SAFETY RECALL NOTICE

HITCH MOUNTED BICYCLE RACKS SOLD DURING 2003-2007

NEW with bumper
and pinch point label

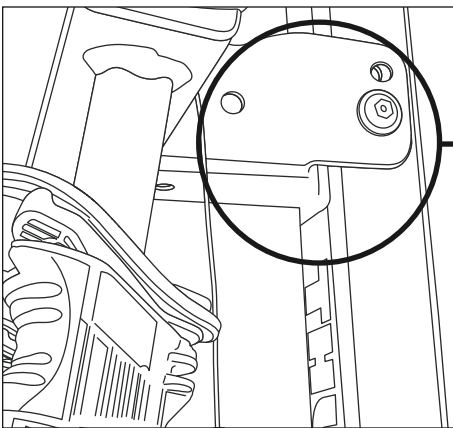
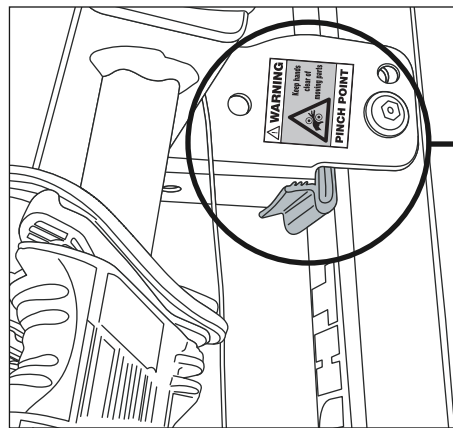
In cooperation with the National Highway Traffic Safety Administration, Thule, Inc. of Seymour, Connecticut is recalling all Hitching Post Pro (934, 934xt, 935, 935xt, 936, 936xt, 937, 937xt, 951, 951xt), Expressway (995, 995xt, 996, 996xt), and Trailblazer (998, 998xt) hitch mounted bike racks sold during the 2003-2007 period. Thule has determined that a pinch point exists between the bike arm bracket and the upright assembly which has the potential of causing a severe laceration or amputation to the user's fingertips or hand when the bike arm bracket is moved to its "down" position.
